Your reference: DA-441/2024 (CNR-75002)
Our reference: DA20241028004481-S38-2

Integrated Development Application
s100B - Subdivision - Torrens Title Subdivision
Pleasure Point Road Pleasure Point NSW 2172, 1//DP875804

Subdivision – Torrens Title Subdivision
Pleasure Point Road Pleasure Point NSW 2172, 1//DP875804
RFS Reference: DA20241028004481-S38-2
Your Reference: DA-441/2024 (CNR-75002)

Development Application and Planning Proposal Review NSW Planning Portal Concurrence and Referral

Site Plan from Endeavour Energy's G/Net Master Facility Model

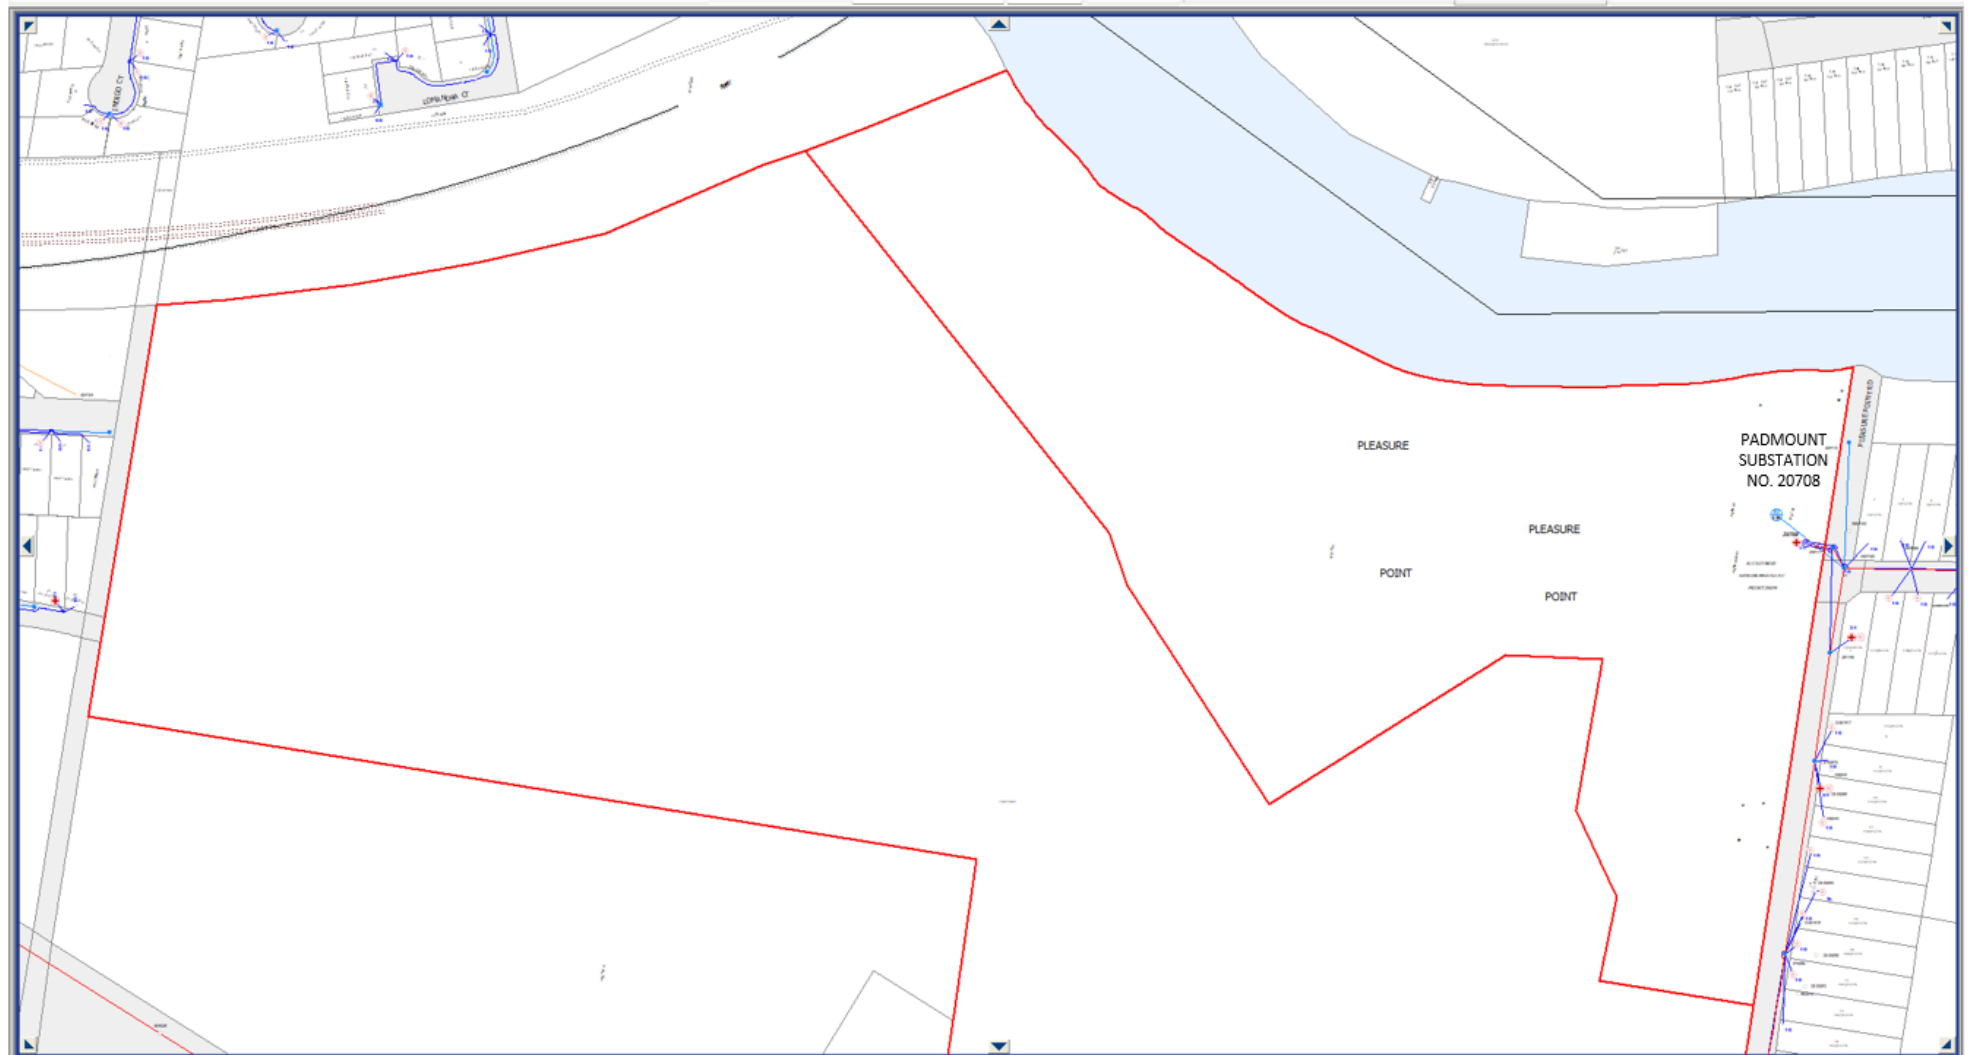
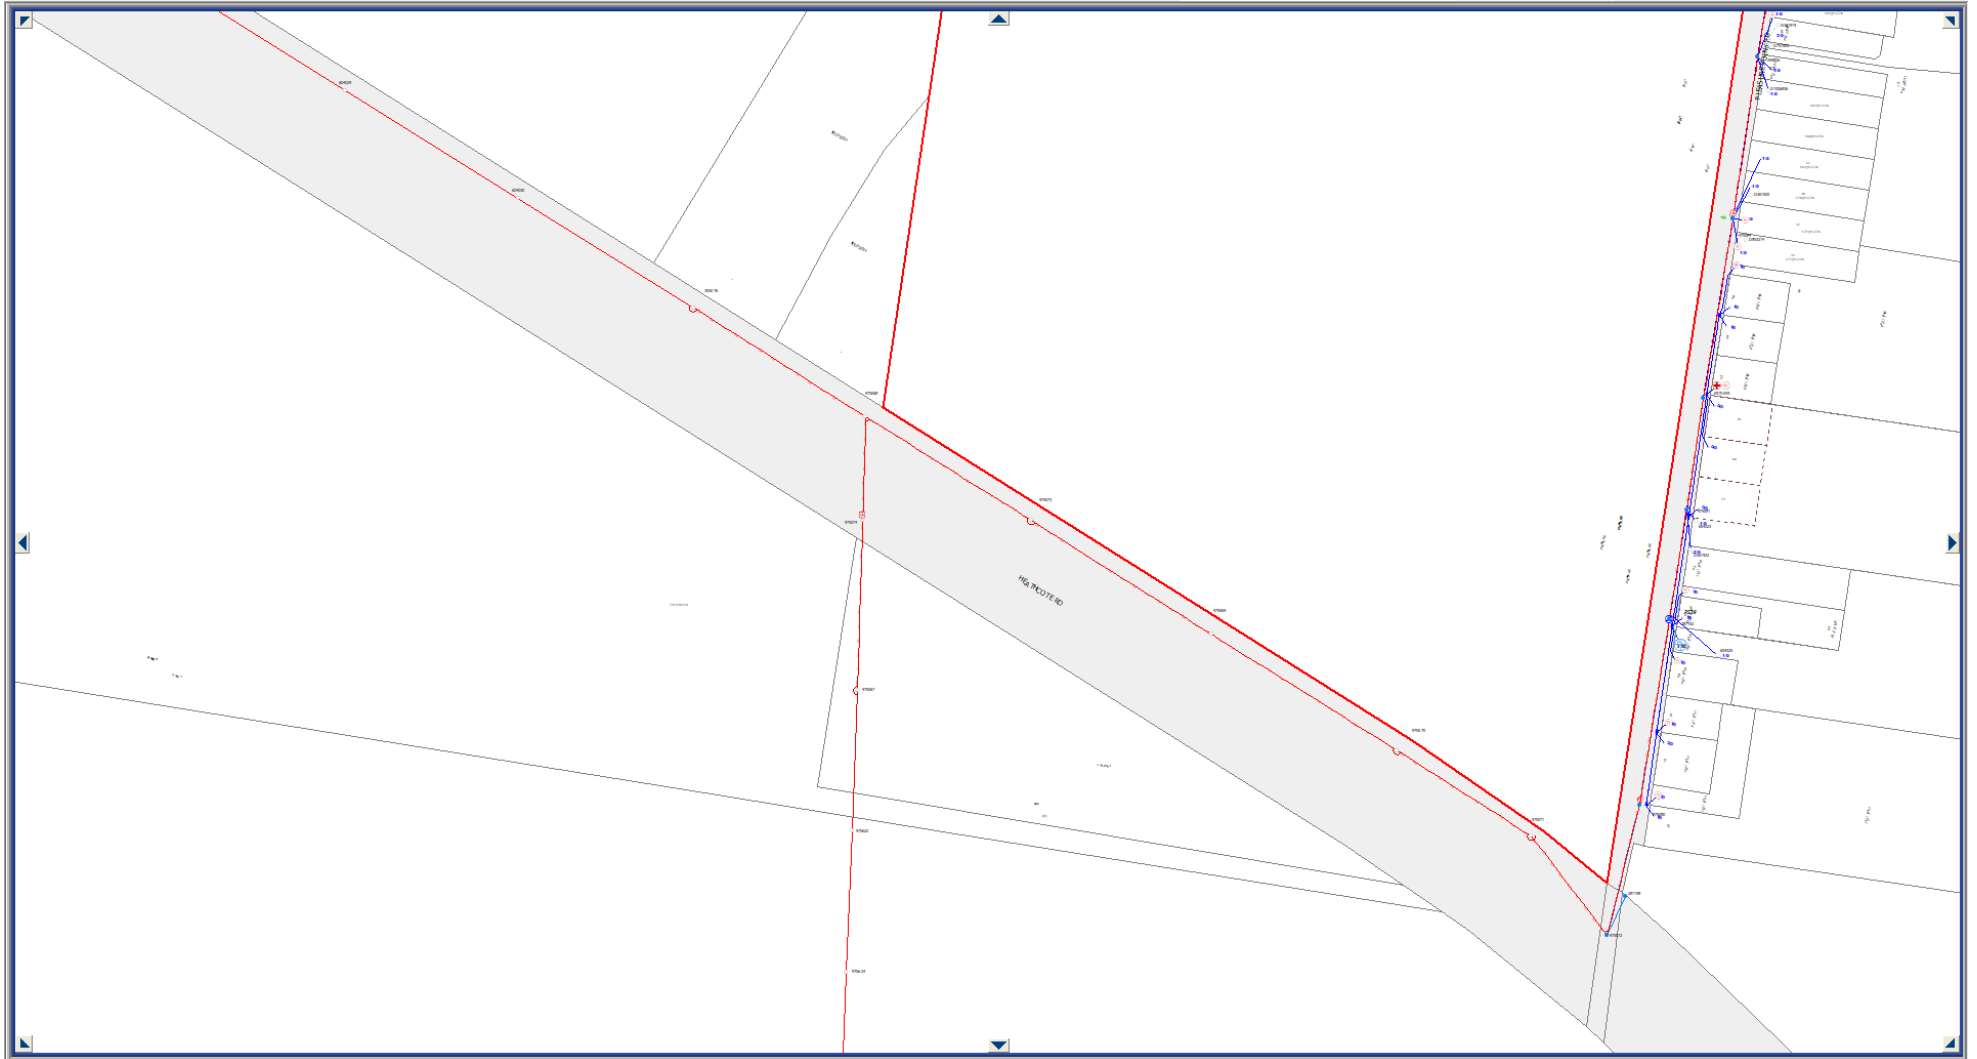
Please note the location, extent and type of any electricity infrastructure, boundaries etc. shown on the plan is indicative only. In addition it must be recognised that the electricity network is constantly extended, augmented and modified and there is a delay from the completion and commissioning of these works until their capture in the model. Easements benefitting Endeavour Energy are indicated by red hatching. Generally (depending on the scale and/or features selected), low voltage (normally not exceeding 1,000 volts) is indicated by blue lines and high voltage (normally exceeding 1,000 volts but for Endeavour Energy's network not exceeding 132,000 volts / 132 kV) by red lines (these lines can appear as solid or dashed and where there are multiple lines / cables only the higher voltage may be shown). This plan only shows the Endeavour Energy network and does not show electricity infrastructure belonging to other authorities or customers owned electrical equipment beyond the customer connection point / point of supply to the property. This plan does not constitute the provision of information on underground electricity power lines by network operators under Part 5E 'Protection of underground electricity power lines' of the *Electricity Supply Act 1995* (NSW).
